DDS- Planning & Zoning: Plan Review Application

HOG RIVER BREWERY RELOCATION
1420 Park St.
Hartford, CT 06106

From: Paul Ashworth
Sent: Wednesday, July 13, 2022 3:34 PM
To: Berschet, Paige; Natalie Sweeney
Cc: Hartford Planning Division
Subject: RE: 1420 Park St - Special Permit Application - P&Z-COMM-2022-0264

Special Permit Application for Approval of Use of an proposed Accessory Outdoor Café associated with a Drinking Place per Section 3.5.2. D, to be reviewed in a CX-2/TOD Zone.

drawing title
PROPOSED SITE PLAN, ZONING INFORMATION, LANDSCAPE SCHEDULE & SITE DETAILS

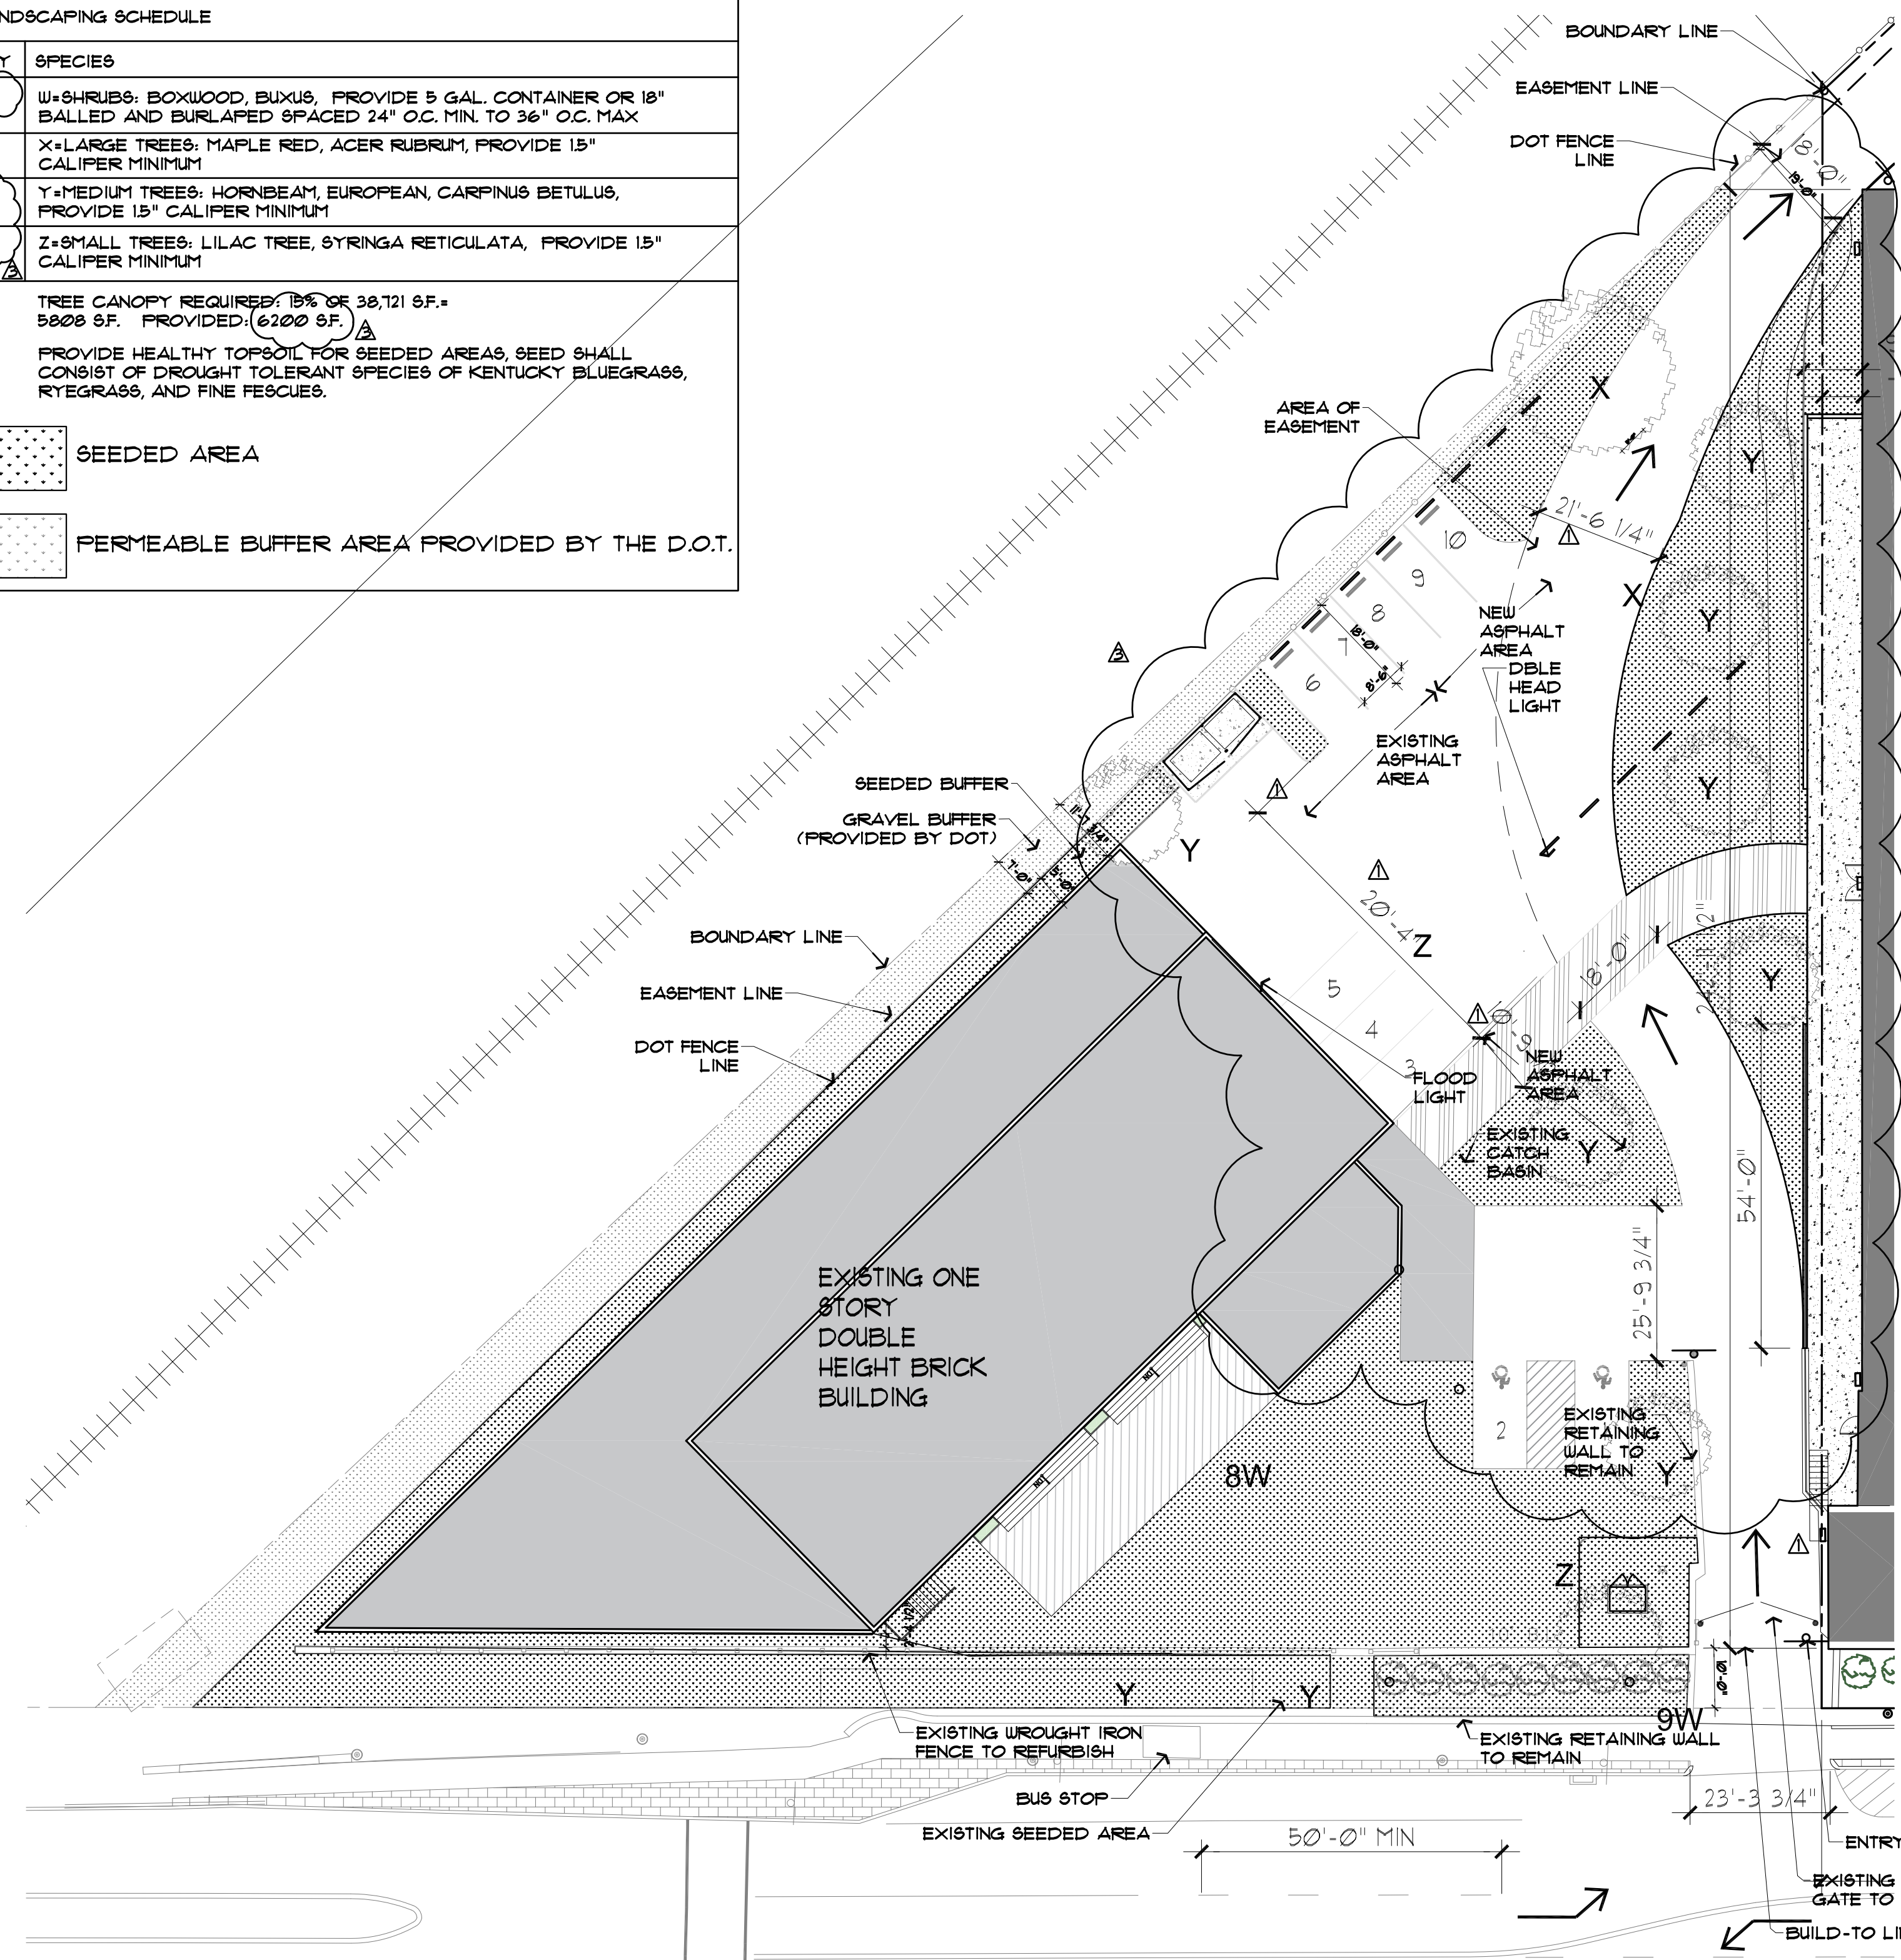
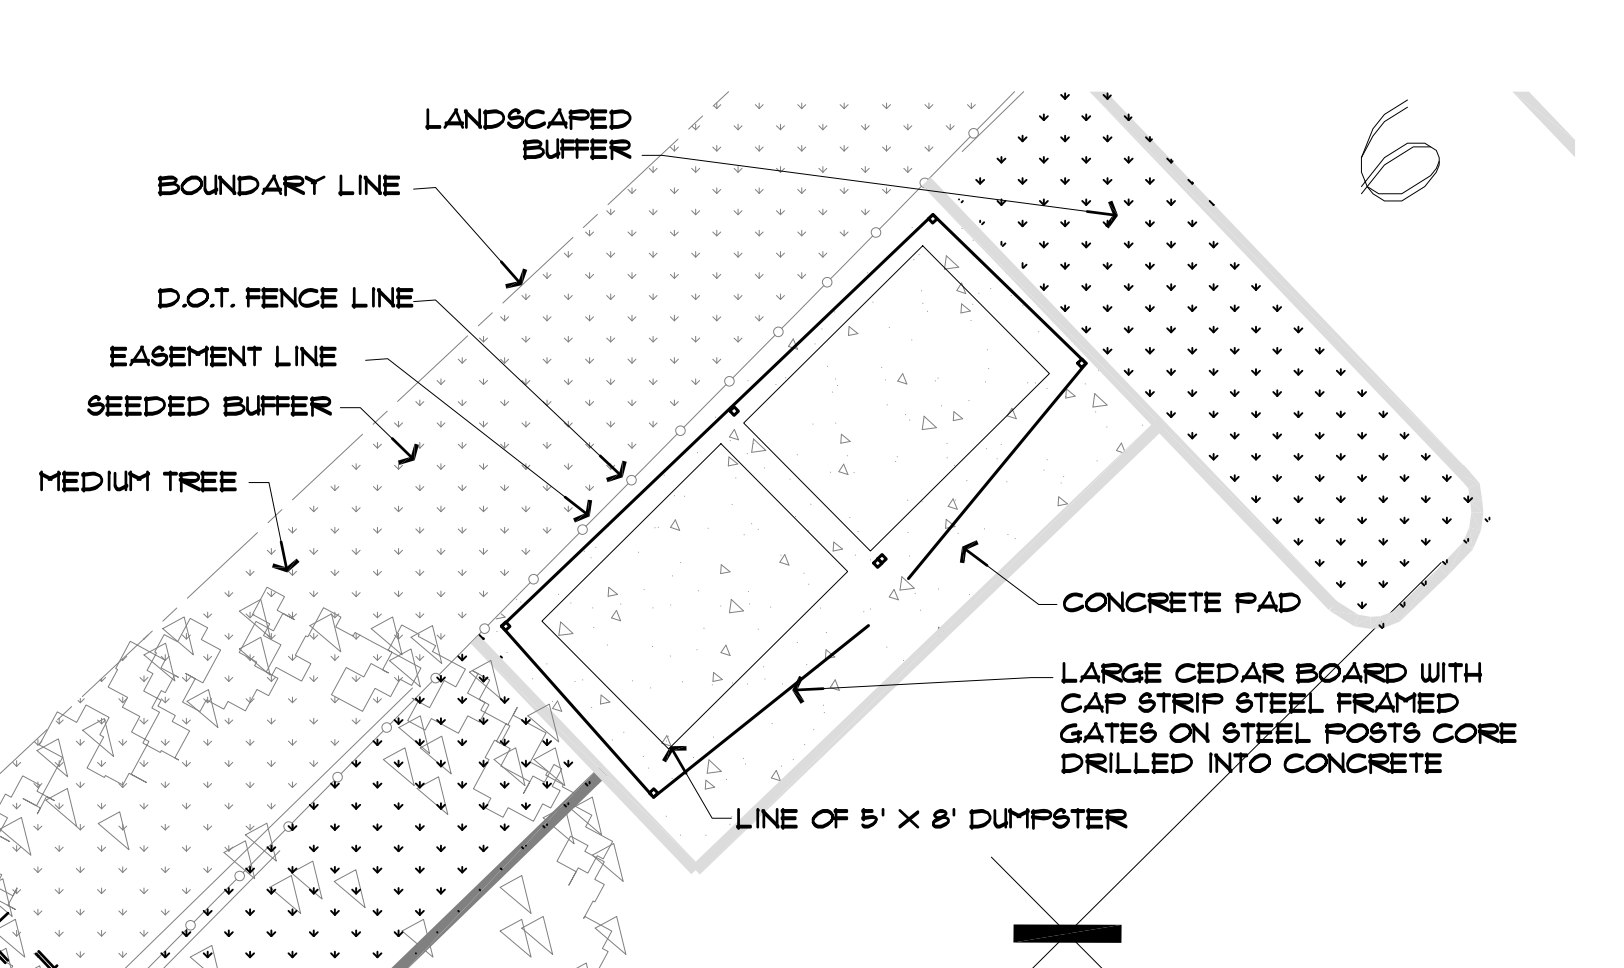
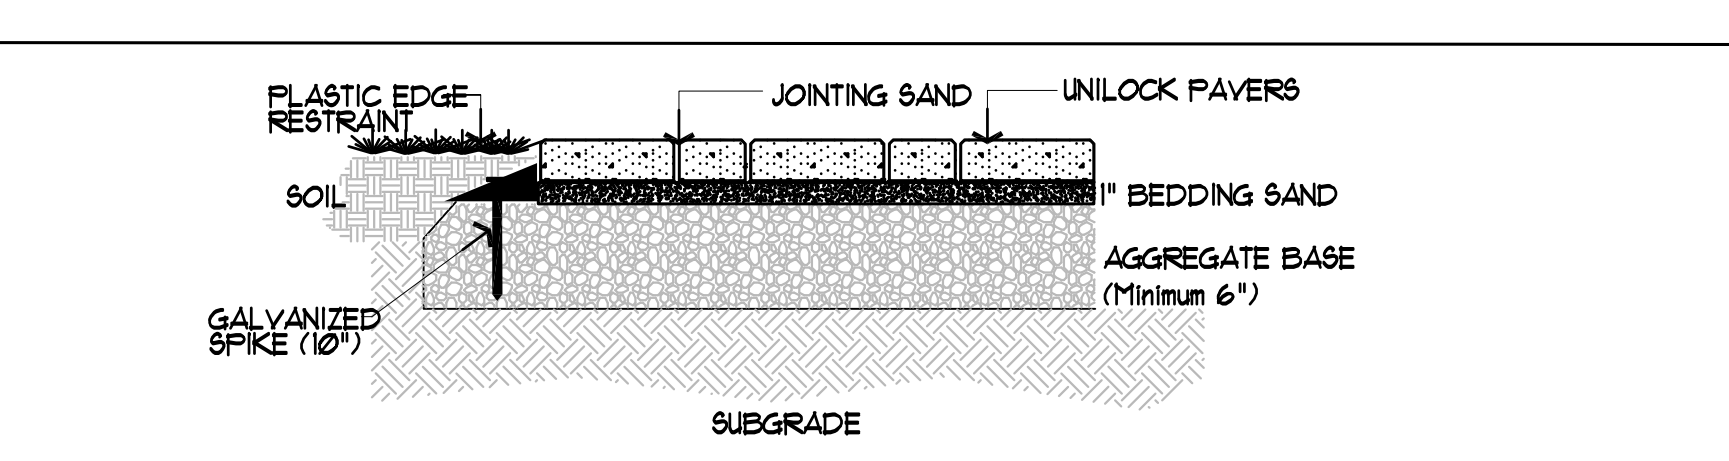
1. Please include a survey in the plan set.
2. Landscape plan was delivered to the City Forester's representative for review.
3. In zoning table on sheet SP-1. Multiple items are marked "Variance Accorded". I don't see a variance(s) on file. Please provide verification of a variance issued by the Zoning Board of Appeals for these items. Please note items #2 and #16 do not require variances. Item number 24 and 25 should be met.
4. Front entrance should be accessible from the street and not required to cross a separate parcel for entrance. Please show a pedestrian accessway from the bus stop directly to the front entrance of the building.

5. Section 4 on sheet SP-1 implies there is a minimum number of parking spaces and does not reflect City of Hartford parking requirements. Maximum parking for this use is 4 spaces per 1000 sf (see employment uses [i.e.craftsman industrial] in Fig.7.2-A). Revise table to show adherence with Hartford regulations.
6. Bicycle parking cannot be more than 50' from the entrance to a building and located on the same lot per Sec.7.3.3. Please show bicycle parking on site.
7. The ADA parking is currently shown in what could be the side or front yard. Parking is not permitted in this location. Please remove from the plan.
Staff found no record of parking being approved in this location in the past.

8. Please confirm parking lot lighting and site lighting is compliant w/ section 7.3.1.J and section 6.15.2 respectively. Please confirm fixture types and provide a photometric plan showing illuminance of the parking and pedestrian areas.
9. Please provide a demolition plan identifying paving to be removed or replaced. Please note new pavement must meet the requirements of section 7.3.1.H.
10. Please provide an erosion control plan or confirm the scope will not trigger section 6.16.3.
11. It appears the total impervious area will be increased. Please provide a stormwater management plan consistent with Section 6.14.2.C unless you can demonstrate how the scope is exempt per section 6.14.2.C(4). If exempt please confirm how the basic requirements of section A are met (6.14.2.A).
12. Please confirm how the tree requirement is met. 15% tree canopy coverage is required in the CX districts.
